CITY OF BETHLEHEM

BUREAU OF PLANNING AND ZONING

(21-001 Sketch/Site Plan Review) – 21040014 – 2958 & 2970 Linden Street– SKETCH PLAN REVIEW –Zoned CS, plan dated April 14, 2021.

Turning Performance Analysis

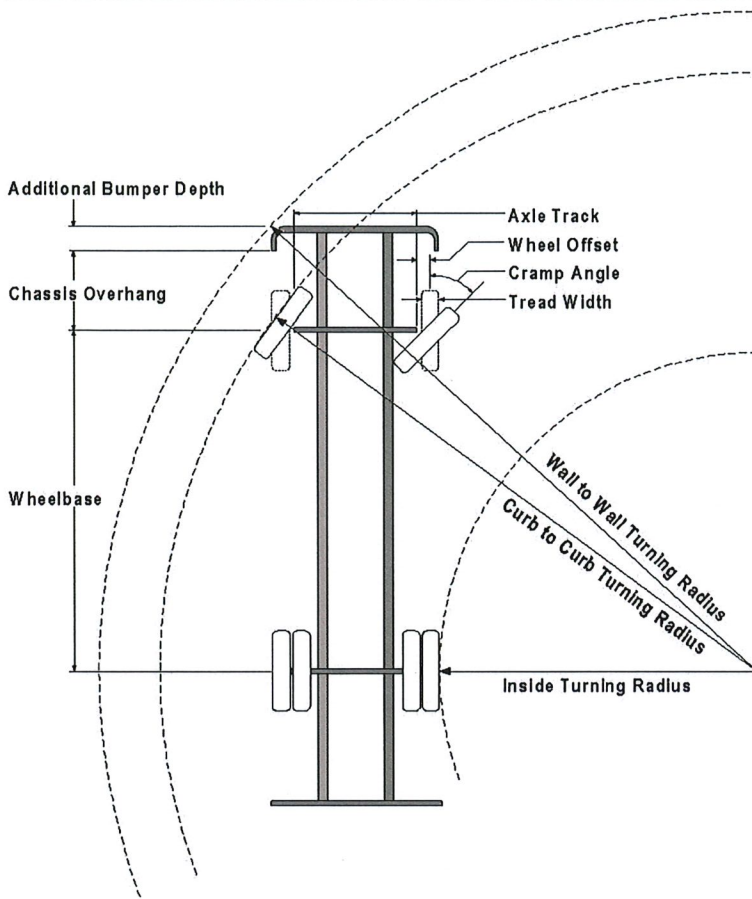
1. The architect/engineer must confirm Fire Department vehicles have the required turning space to access all areas. (See attached turning radius information for our largest vehicle.) Please submit a turning plan.
2. A Knox Box for City of Bethlehem Fire Department access must be installed. (Please add note to plans and location TBD)
3. All 'Fire Lanes' must be identified and properly marked. (Refer to International Fire Code, 2009 ed., Section 503 and Appendix D for additional information. Locations for signs and markings can be determined as the project progresses.)
4. The 2 fire hydrants and the FDC location indicated on the utility plan are approved as indicated. Contact the Office of the Fire Marshal for approval of any changes.
